**Section 12A Planning Application for Proposed Amendments to the Tung Chung Valley Outline Zoning Plan to Rezone "Residential (Group C)2" Zone to "Residential (Group B)" Zone in Support of Private Residential Development at Various Lots in D.D. 1 TC and Adjoining Government Land, Tung Chung, Lantau Island (Application No. Y/I-TCV/1)**

**Appendix A**  
**Responses-to-comments Table**

**Replacement Pages of Traffic Impact Assessment**

FIGURE 5.4

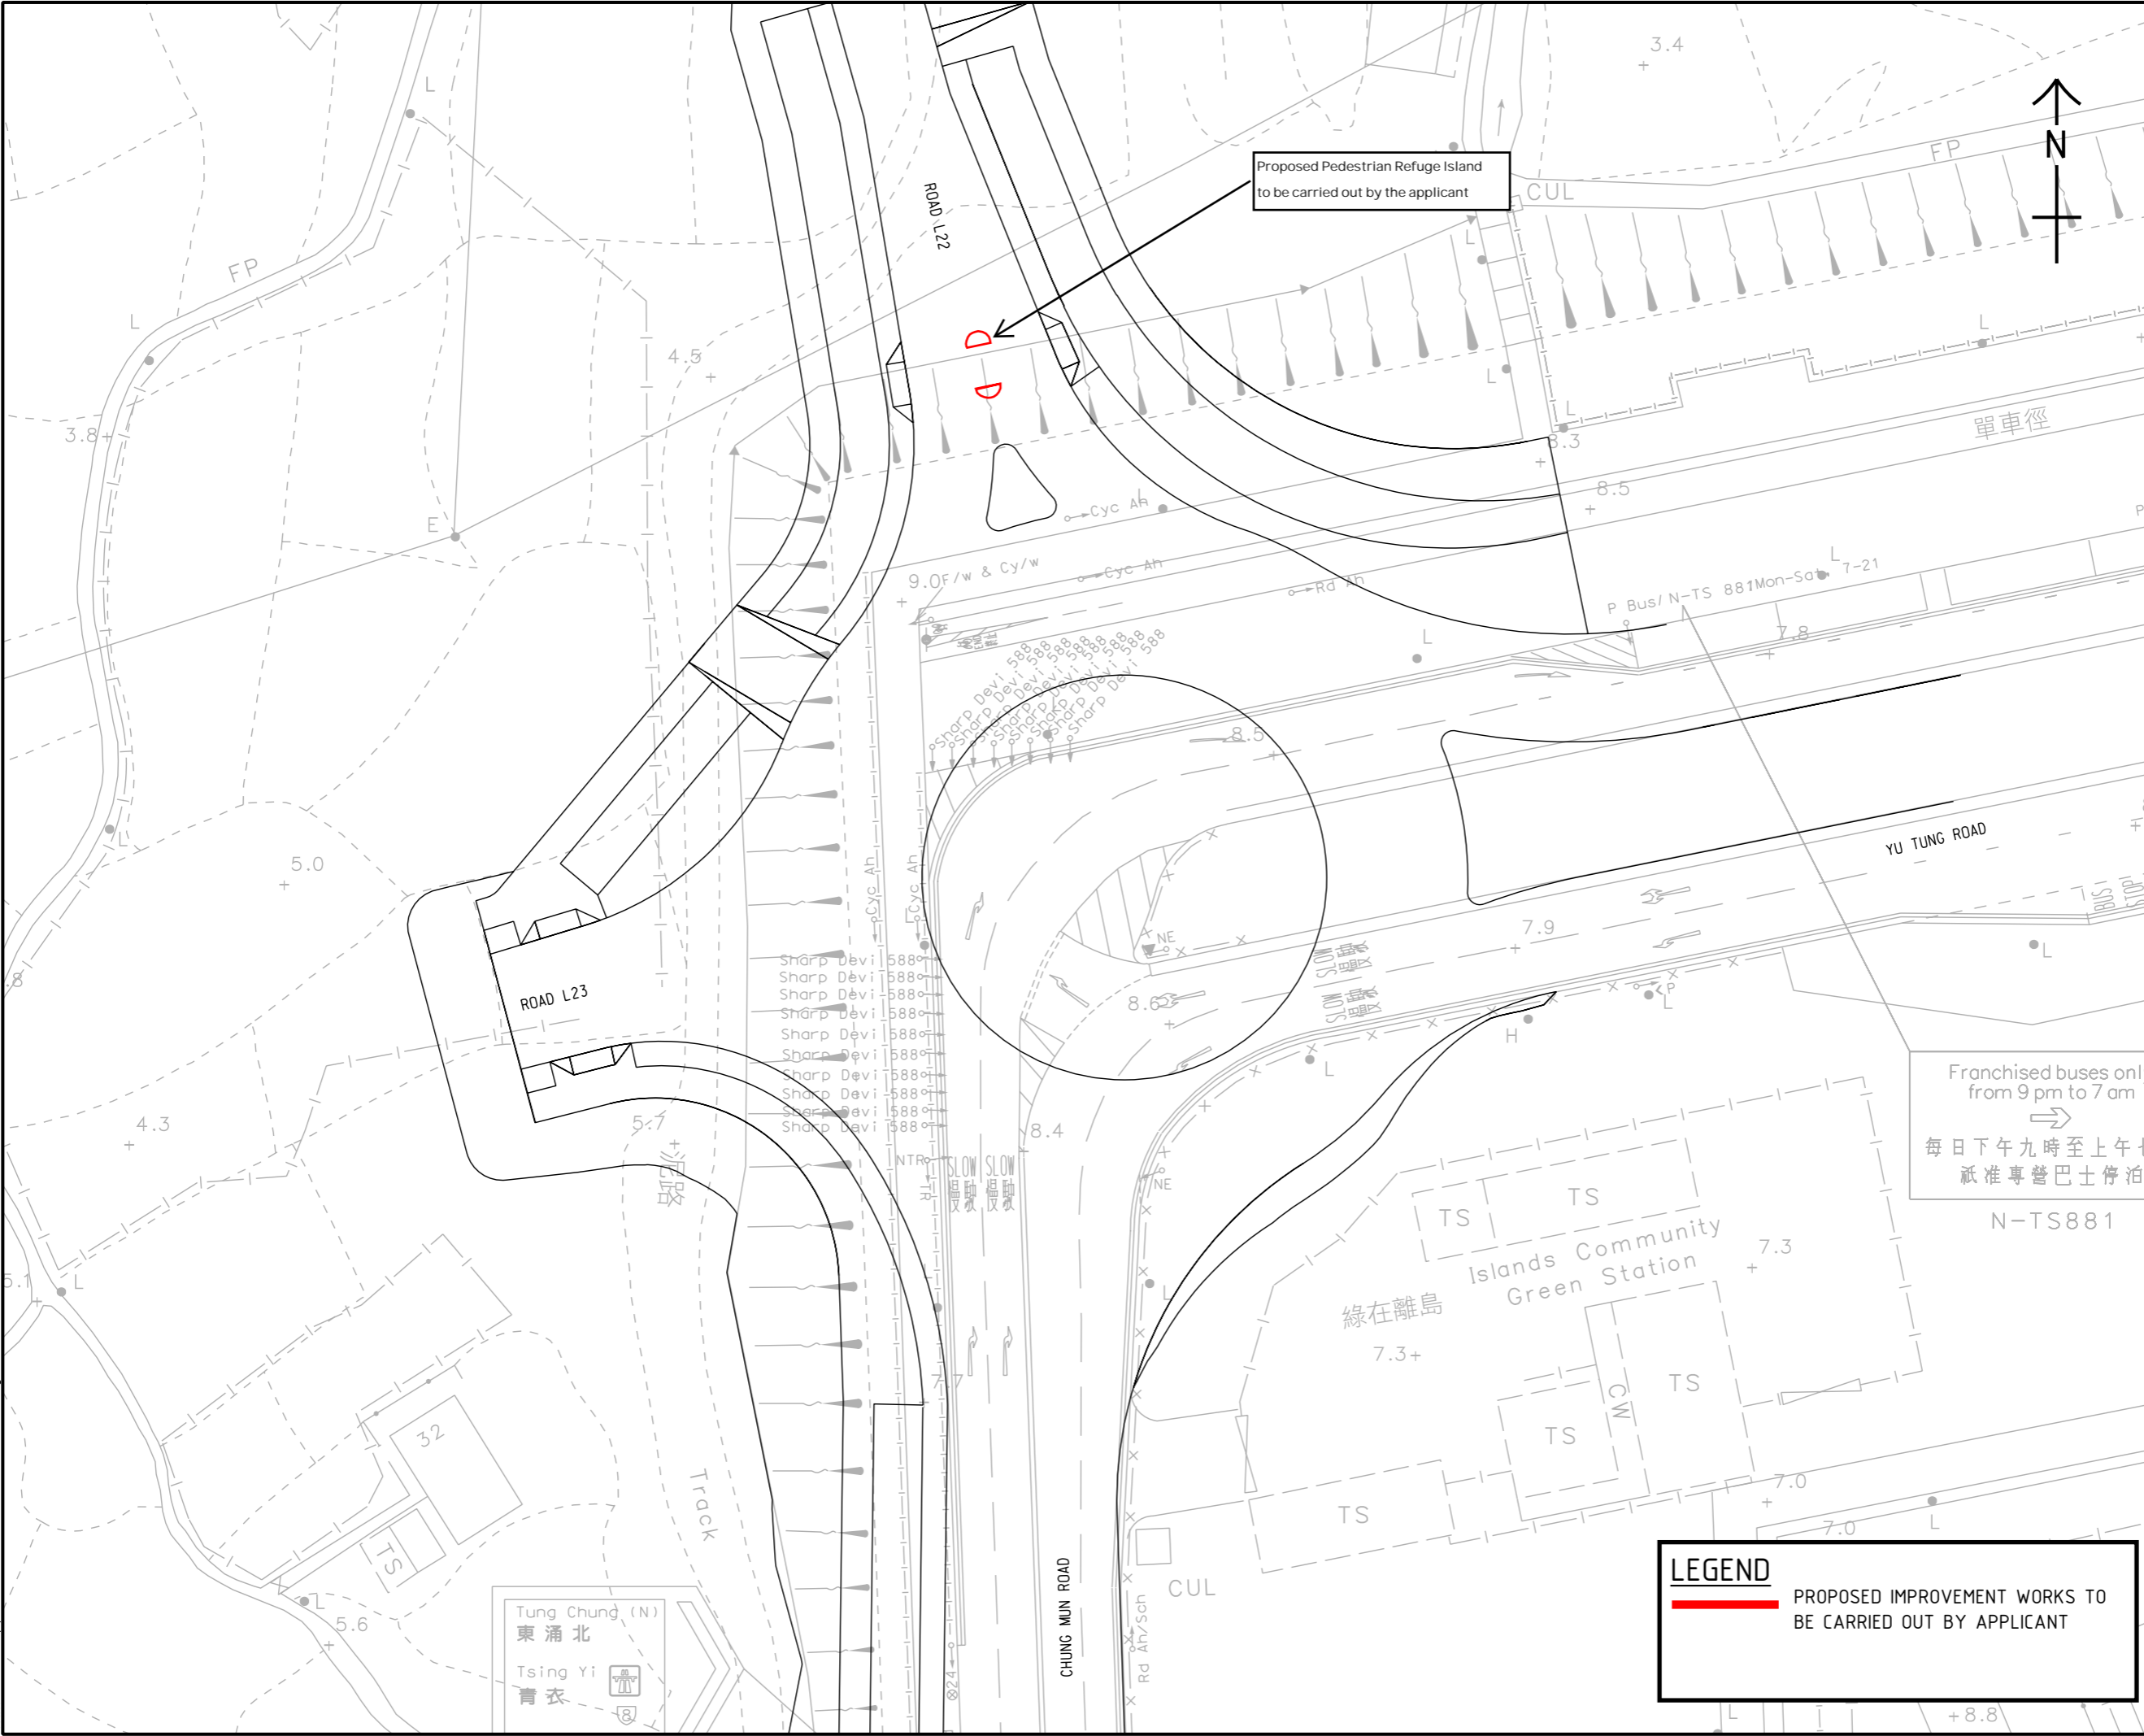
1.2	RtC item 1.2 / Re. Para 5.4 – For the works that can enhance the safety for pedestrian in crossing Road L22, please advise if any proposal after your liaison with CEDD.	Refuge island has been proposed to enhance the pedestrian safety. Please refer to Figure 5.4 in <b>Attachment 1</b> for your easy reference.

5.4.9 Considering the major pedestrian route between the subject site and MTR Tung Chung West Station would across Road L22. In order to enhance pedestrian safety when crossing Road L22, it is proposed to supplement a pedestrian refuge island. The proposed layout is shown in **Figure 5.4**.
